RE: Independent Design Consultants Report

DESIGN CONSULTANT REPORT

76 PLACE *at Market East*

Design Review #1

Proposed Ground Floor Plan Image source: March 2024 CDR Submission

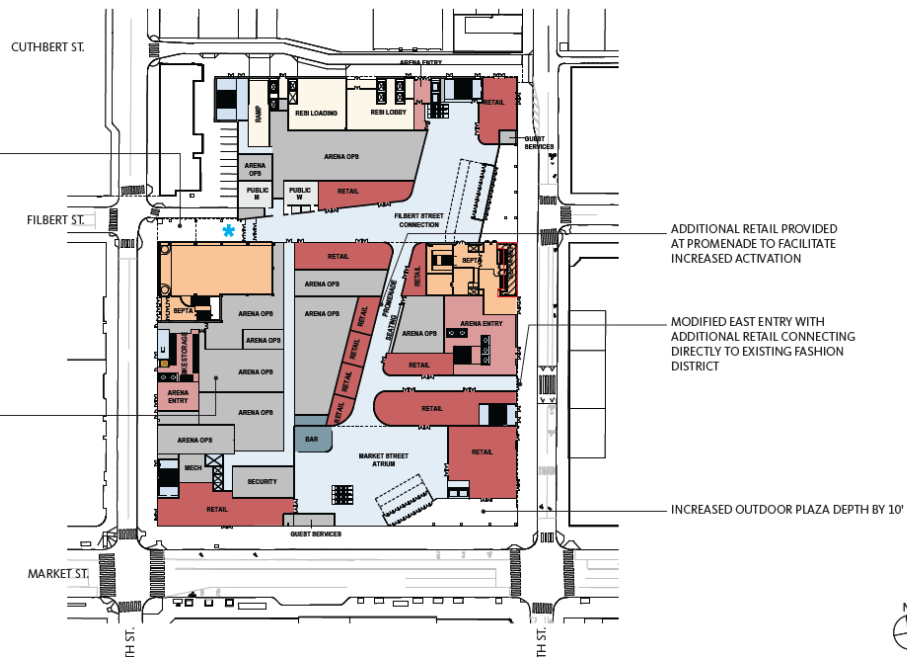
- 1. Ground Floor Plan:** The second submission contains a more informative ground floor plan. The additional details help to clarify the Development Team’s intent for back-of-house (BOH) functions. The addition of this information helps better inform the needs of the arena for security, food and beverage and other functions.
- 2. Retail Activation:** The Review Team agrees with the added retail activation within the internal passageways as shown in the provided ground level floor plan below.
- 3. Seating:** The Review Team agrees with the inclusion of permanent seating to activate the internal passageway where retail is not provided.
- 4. 10th Street Entry:** The Review Team agrees with the relocated mid-block entrance on 10th Street that aligns with the existing entrance to the Fashion District Mall to the east.

Event Day Rendering. Image source: March 2024 CDR Submission

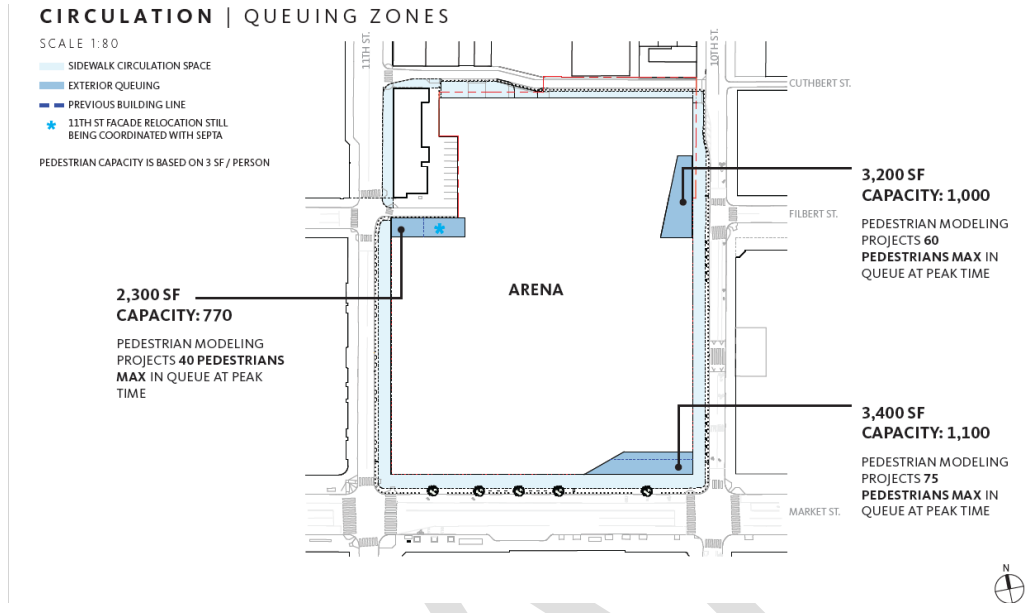
- 6. Transparency:** The Review Team appreciates the high degree of transparency shown in the rendering.

Sidewalk Detail. Image source: March 2024 CDR Submission

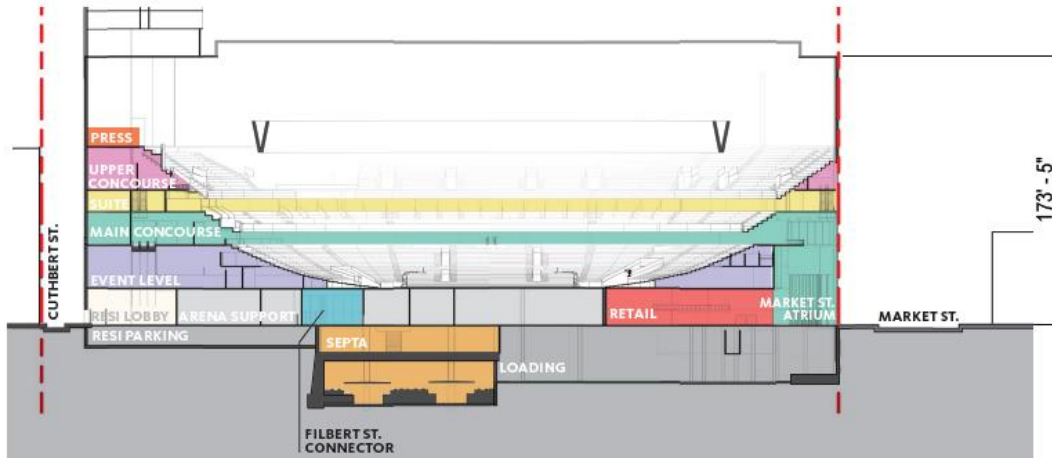
10. Bike Rack Orientation: The Design team suggests parallel bike rack parking (to the street) to maximize walking zone widths on all surrounding sidewalks. The Development Team should consider a bollard that is also a bike rack to reduce sidewalk clutter.

Entrance Detail. Image source: March 2024 CDR Submission

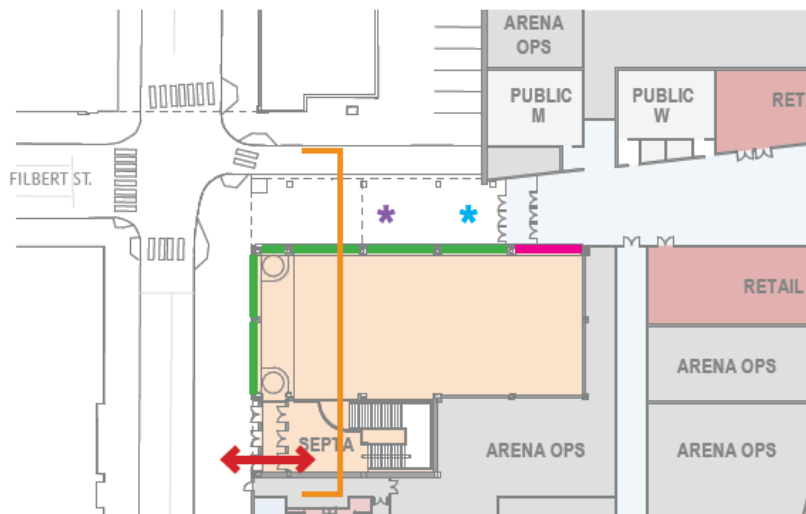
12. Relocated Filbert Street Entry: The Review Team notes the revised Filbert Street entrance and door location which are improvements from the prior plan submission in November 2023. This new proposed setback will allow for additional light and air into the SEPTA station and Jefferson Regional Rail Platform.

Section Detail. Image source: March 2024 CDR Submission

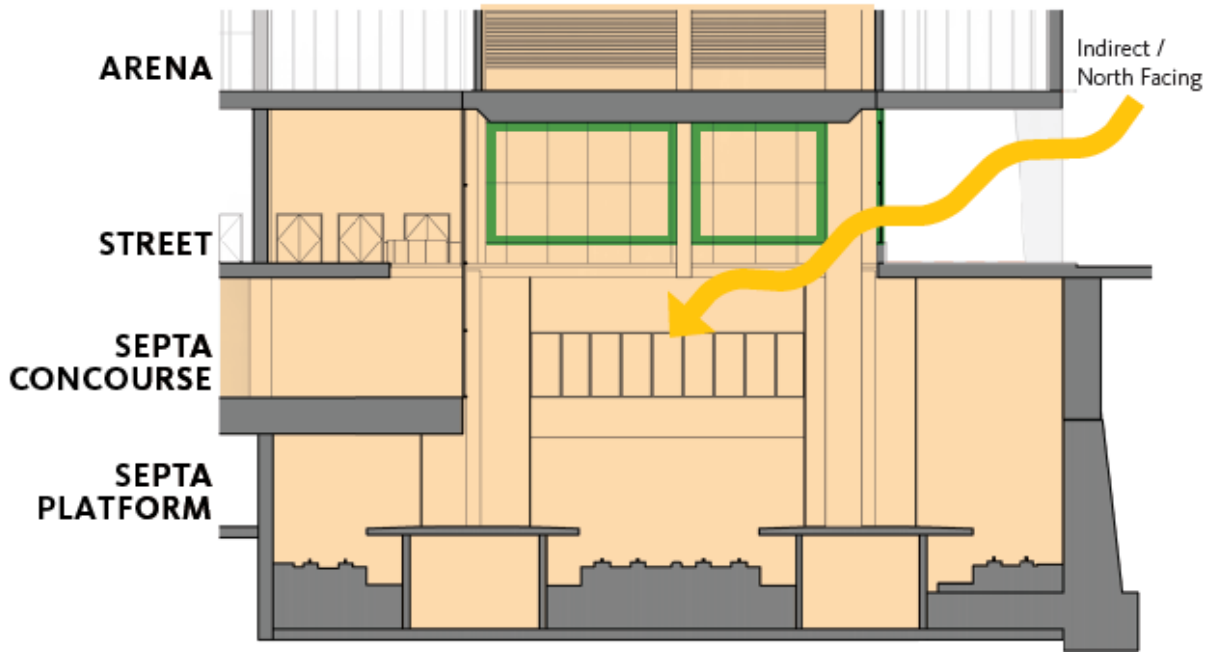
13. Station Section Drawing: The “Jefferson Station Atrium Cross Section” is an extremely helpful drawing which shows the relationship of the new building to the SEPTA train platform and how indirect daylight will filter into the platform area. Note that the arrow indicates daylight, but not direct sunlight.

Event Day Rendering. Image source: March 2024 CDR Submission

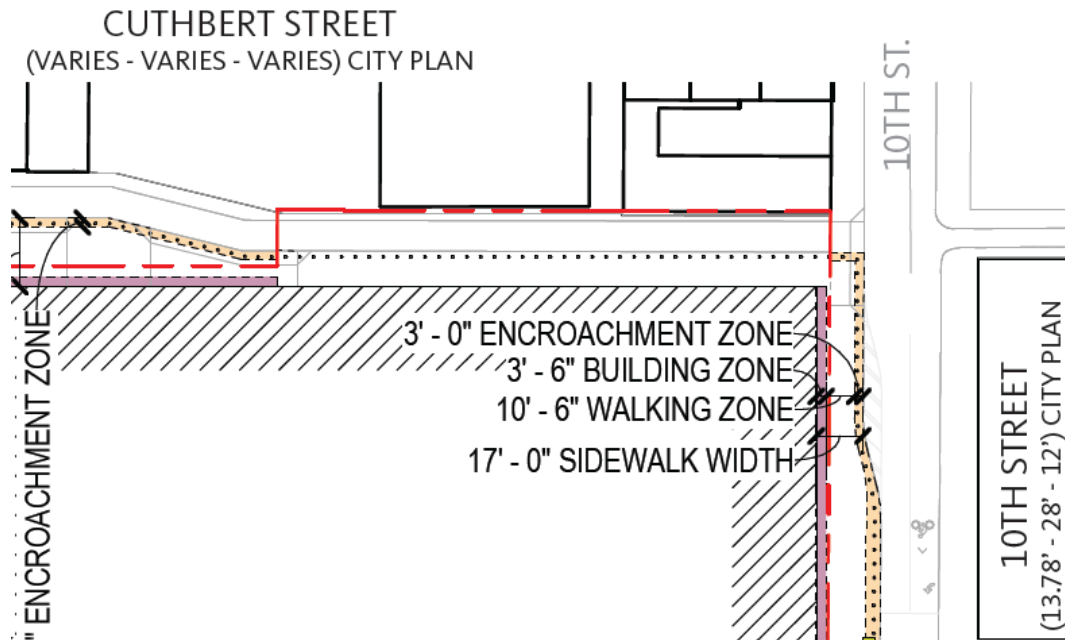
11. Structural Support: The Design Review Team still questions what is actually supporting the glass wall (and the arena). Indications of structure are still very notional and unconvincing.

Sidewalk Plan Detail. Image source: March 2024 CDR Submission

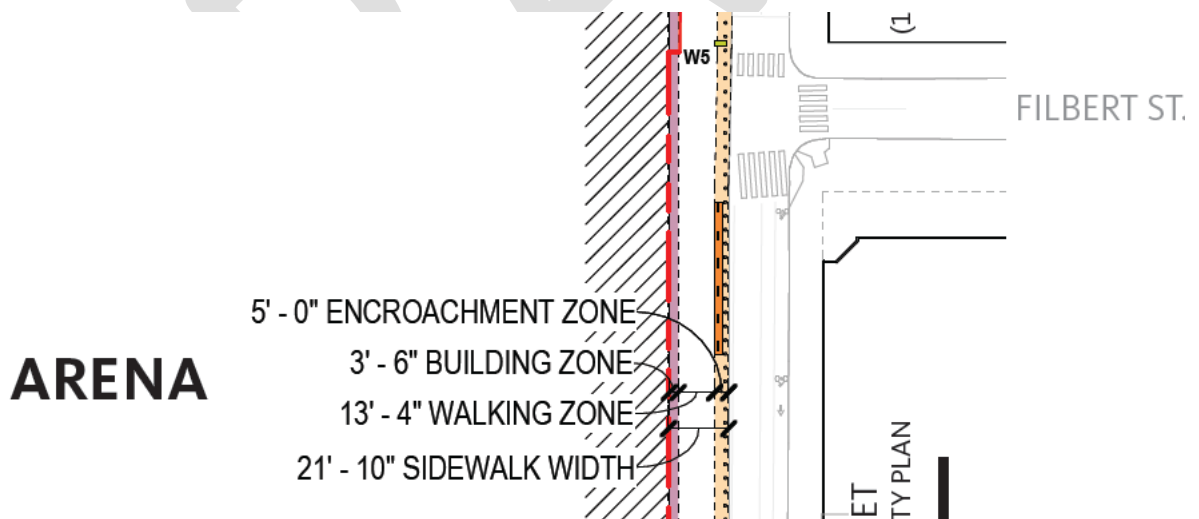
15. Bike Racks: Need more information on the nature and orientation of bike racks on the critically narrow 10th and 11th Street sidewalks.

Lane Closure Details. Image source: March 2024 CDR Submission

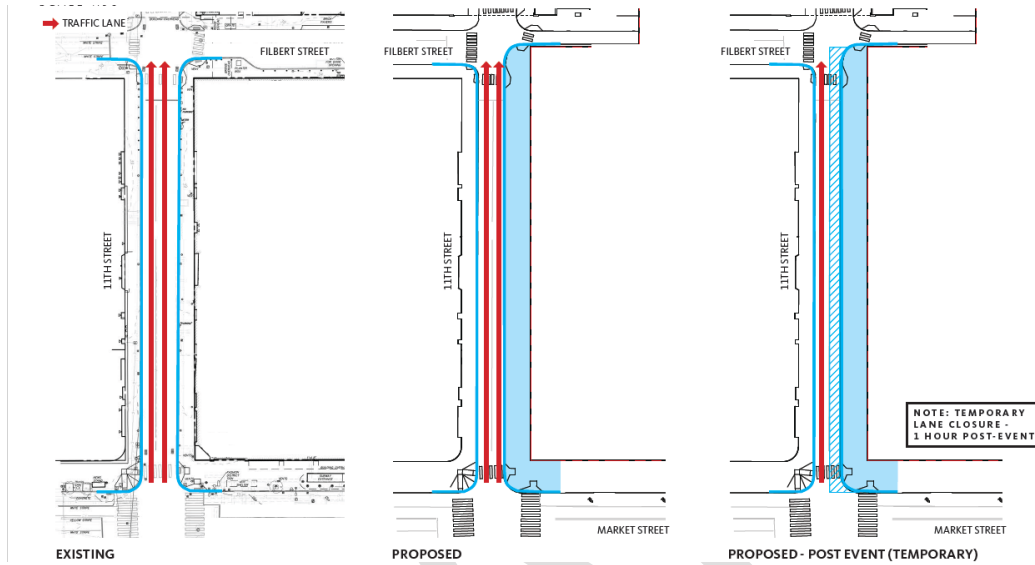
17. Temporary Lane Closures: Submission states: "NOTE: Temporary Lane Closure - 1 hour post-event." It is not clear what the purpose of the post-event lane closure is. The way in which the lane closure is designed is also in question. Is this through temporary measures (event day safety cones or flex posts) or more permanent design measures such as paving options? More information is needed regarding the design aspects of the proposed closures.

Proposed Ground Floor Plan Image source: March 2024 CDR Submission

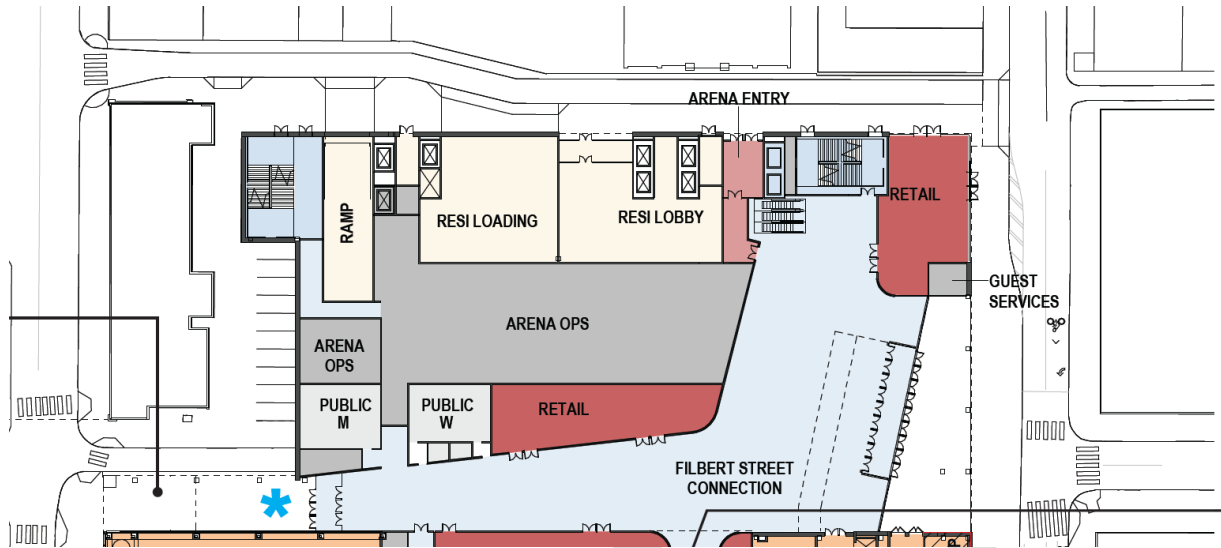
- 8. Deactivated Interior Frontage:** Area designated “Arena Ops” is still an unfortunately deactivated frontage facing a major point of entry for the arena (from 10th Street).

Proposed Ground Floor Plan Image source: March 2024 CDR Submission

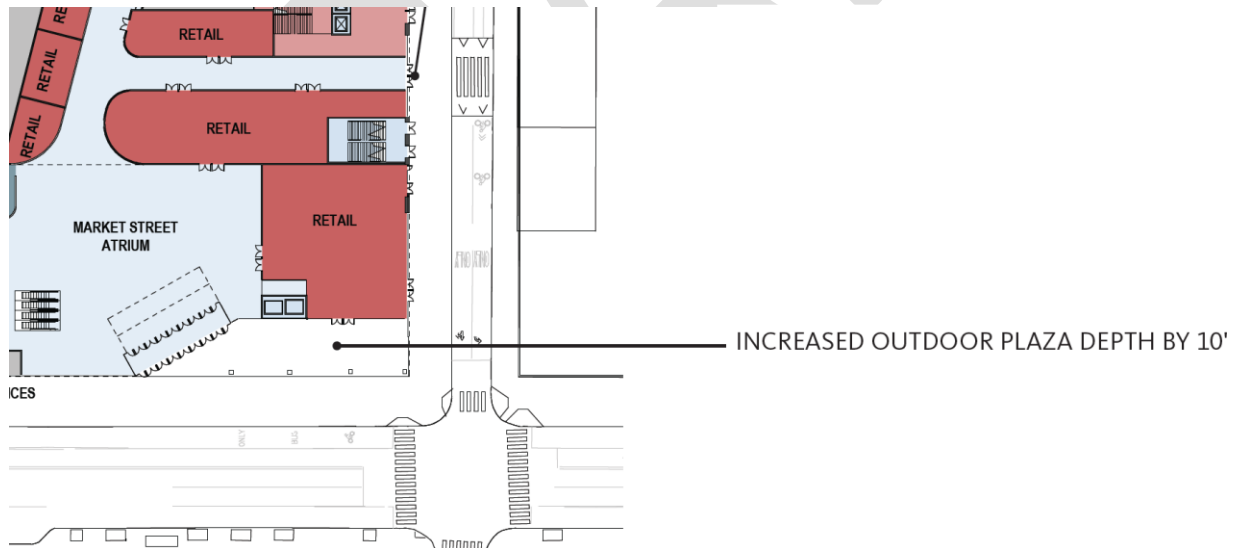
- 9. Arrival Zone:** Increased square footage for entry spaces is appreciated, although the primary (10th and Market Streets) and secondary entrances (11th and Filbert Streets and 10th and Filbert Streets) still fall short of being civically designed or programmable public plazas.

Proposed Ground Floor Plan Image source: March 2024 CDR Submission

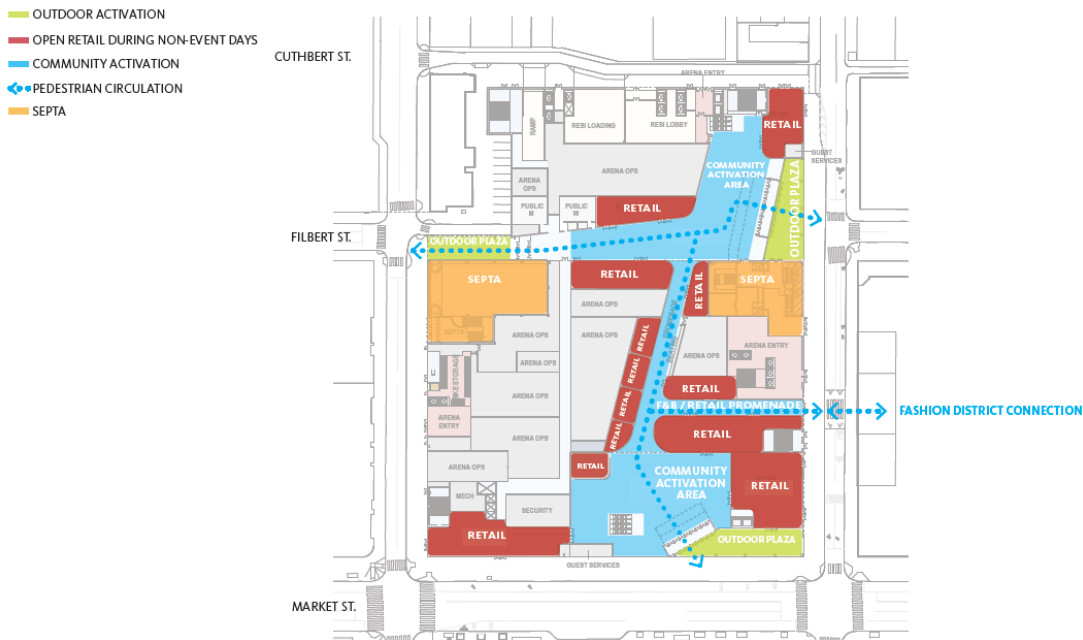
10. Outdoor Activation: The “outdoor activation” spaces are important and necessary. The Review Team is unsure they would qualify as plazas, especially during non-event days. Plaza spaces have a more discrete form and a defined edge condition typically by either buildings or landscaping. While it is encouraging to see the spaces increase in overall square footage, more information is needed regarding their design, materials and what brings people to utilize these spaces on non-event days.

Circulation | Queuing Zones. Image source: March 2024 CDR Submission

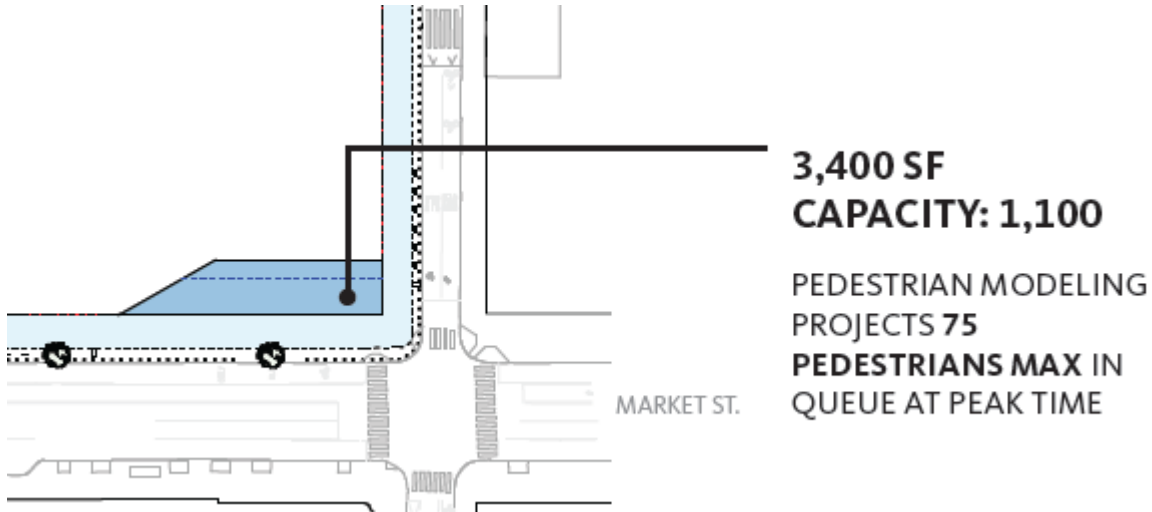
12. 10th & Market Street Arrival Zone: Stated capacity: 1,100 people. The Review Team notes the size of this primary open space should be greater. Consider other mitigating capacity fixes on adjacent corners of the intersection or how more of the interior space can become outdoor amenity space.

Proposed Ground Floor Plan Image source: March 2024 CDR Submission

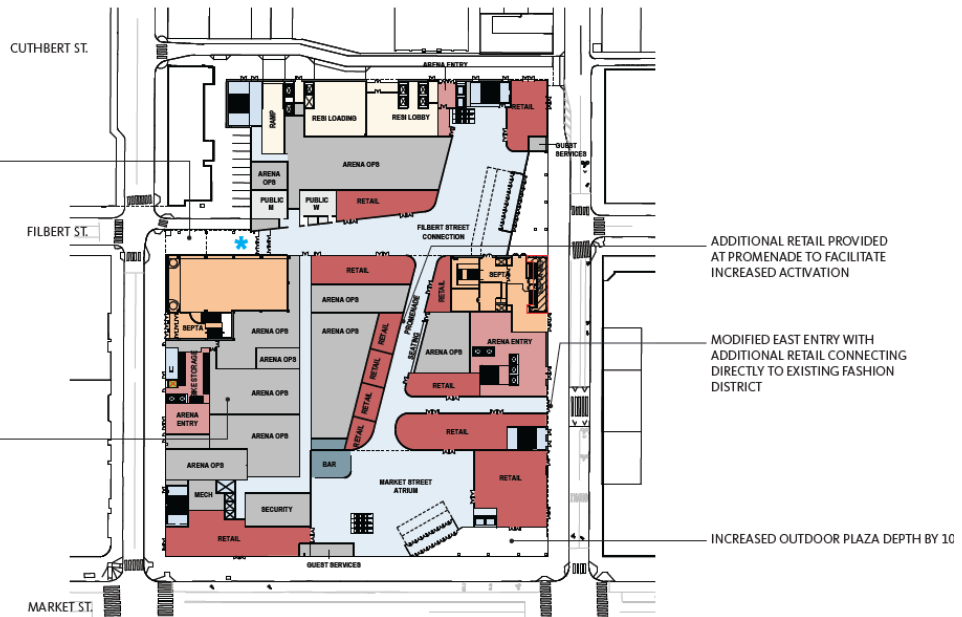
- 1. Public Open Space:** While arrival plazas have been slightly enlarged in the second submission, the Review Team remains concerned that a significant public open space is still missing from the proposal.
- 2. Operational Functions at Ground Level:** Regarding the various gray spaces labeled “Arena Ops”, most or all of these functions are recommended to occur at the event floor level. Review Team wonders what is requiring the Development Team to maintain so many back of house functions at street level. There are very few arena operations functions that need to be at street level, yet a great many of them (though unspecified) seem to be located here.

Proposed Ground Floor Plan Image source: March 2024 CDR Submission

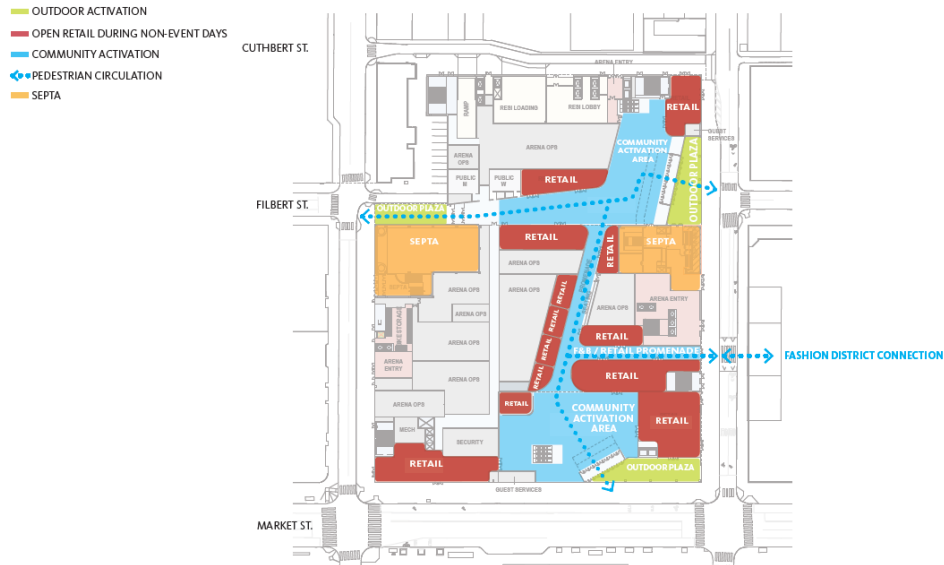
- 3. Community Activation:** While the Review Team appreciates the second submission designating the northern lobby as a "community activation area", our suspicion is that it will be less active than the similarly labeled space on Market Street. More information is required regarding how these two functions (residential tower and its associated elements and the arena) work together (if at all).
